RECEIPT DATE: 4/27/22 **ONSITE SEWAGE DISPOSAL SYSTEM**

APPROVAL DATE: 5/17/22 **PERMIT: CONSTRUCTION**

PROPERTY ADDRESS: 1421 HERITAGE RIDGE ROAD, WOODBINE, MD 21797

ONSITE SEWAGE DISPOSAL SYSTEM DESIGN PLAN
LOT 25
LINDEN GROVE
 LIBER 15899, FOLIO 246
 PLAT NO. 25722
 ELECTION DISTRICT No. 4
 HOWARD COUNTY, MARYLAND
 ADDRESS: 1421 HERITAGE RIDGE ROAD
 WOODBINE, MARYLAND 21797

1421 Heritage Ridge Rd

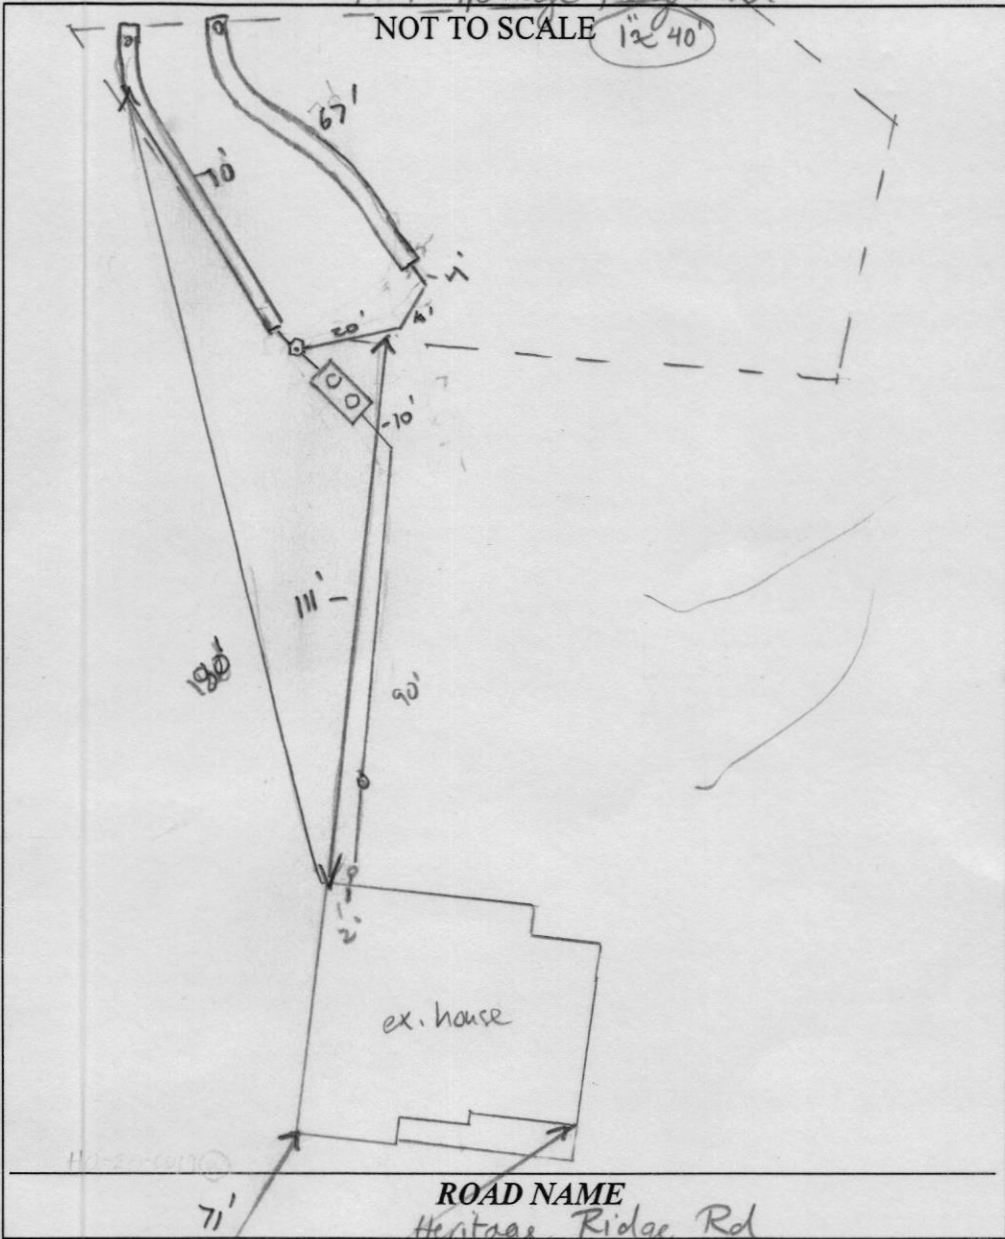
5/5/22 Plumber accidentally installed hung sewer. There is sufficient grade to cover SL. Contractor had no stakes, call for layout. (SF)

5/16/22 2x68' trenches staked out on contour (SF)

5/17/22 Trenches complete installed per plan. Alas trench abs pipes were "light weight" pipe w/ push caps. Told contractor these need to be sch 40 above stone and covered above grade w/ screw cap. OK to cover (Fwy)
